Subject: Oakley Generating Station Project (09-AFC-4)  
Wetland E Management Plan - Updated June 2010

Subject: Wetland E Management Plan for the Oakley Generating Station – Updated  
June 2010

## Wetland E Management Plan for the Oakley Generating Station – Updated June 2010

**Figure 2**  
**Wetland E Preserve**  
**Wetland E Enhancement Plan**  
 June 2010

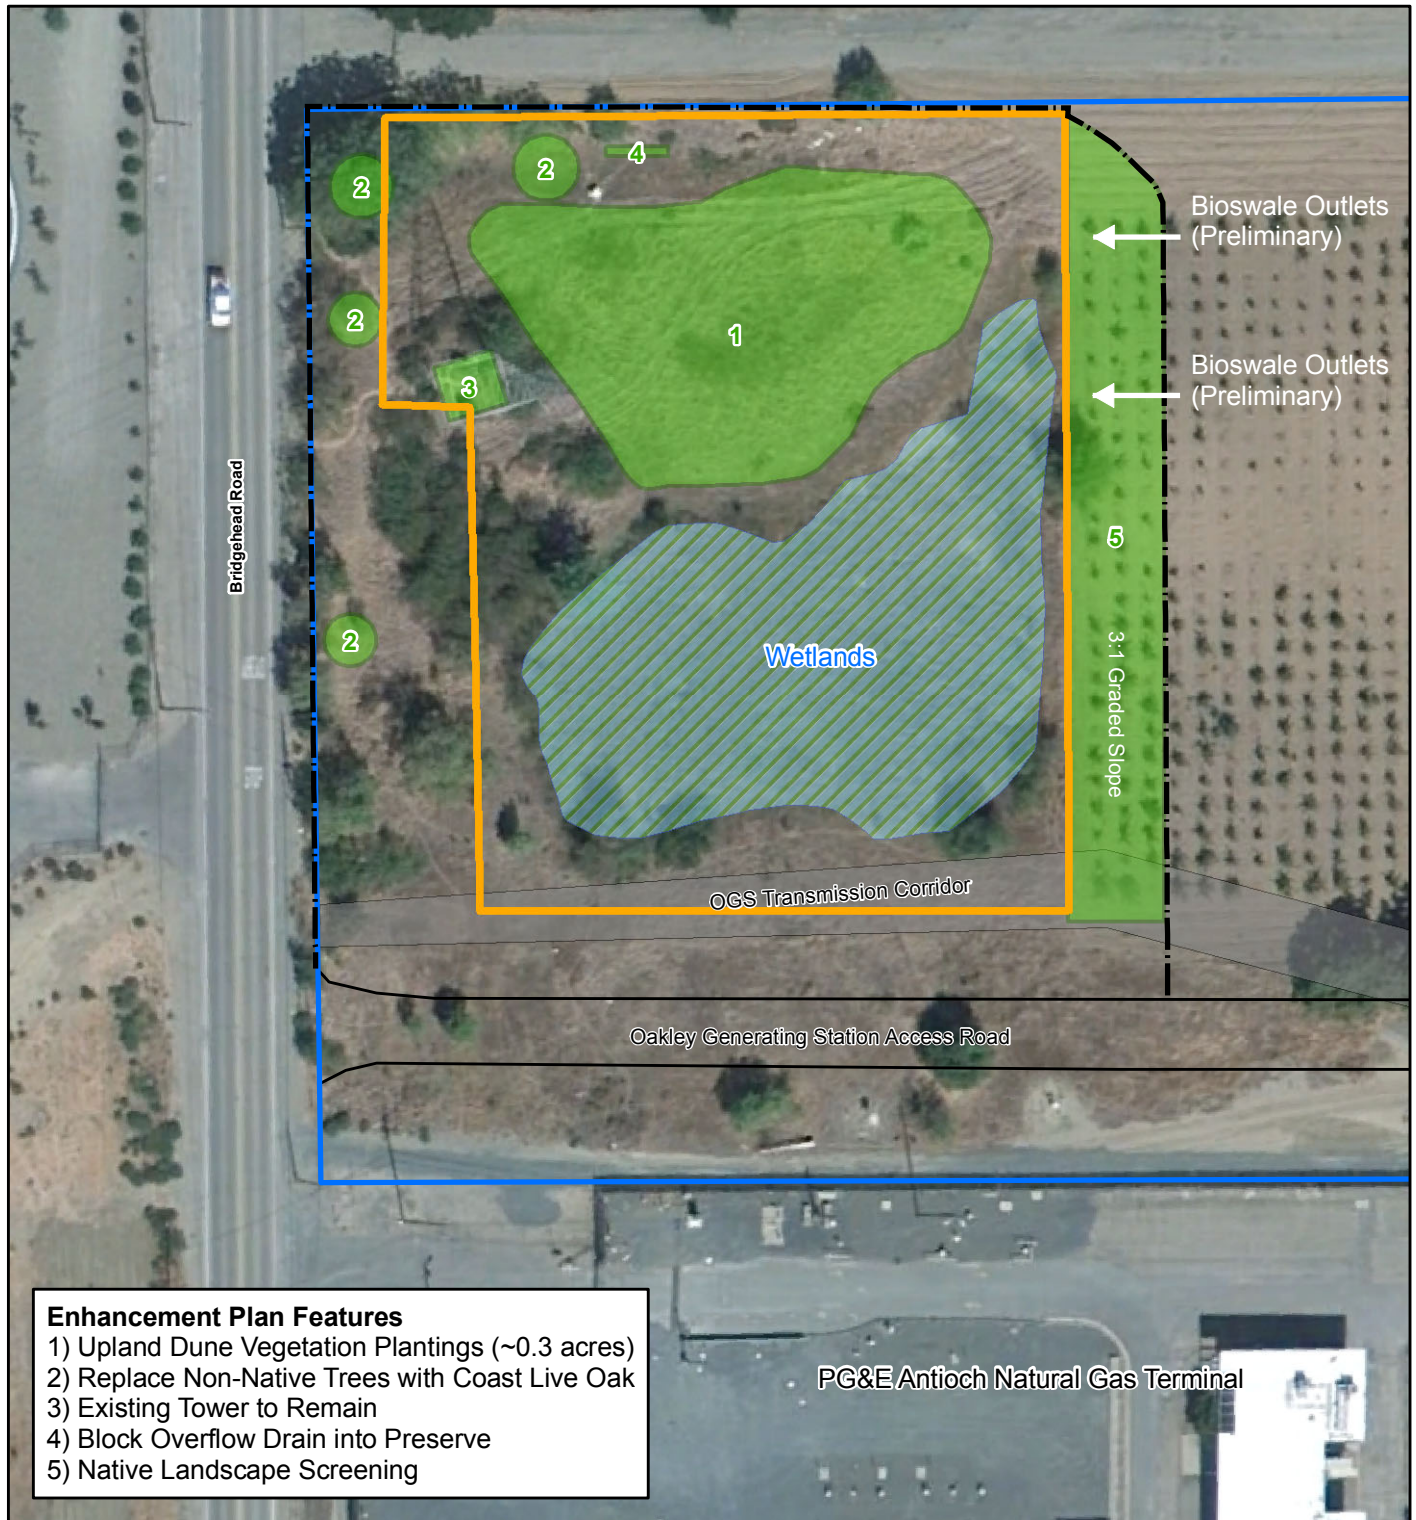
The attached Wetland E Management Plan has been revised to remove the public access features as agreed to during our telephone conversation on May 20, 2010. The public access features removed include the parking spaces, picnic table, footpath, interpretive signage, and road signage.

The outlets of two bioswales arising from the northern and southern halves of the OSG site are shown in Figure 2. The outfall structures will consist of a rock pad constructed outside the wetlands preserve. In addition to the use of bioswales, the drainage design is currently being revised to include a detention pond. The inclusion of a detention pond will allow for increased management of the water released from the bioswale outlets during large rain events, thereby reducing the risk for excessive runoff and flooding of the pond during large rain events.
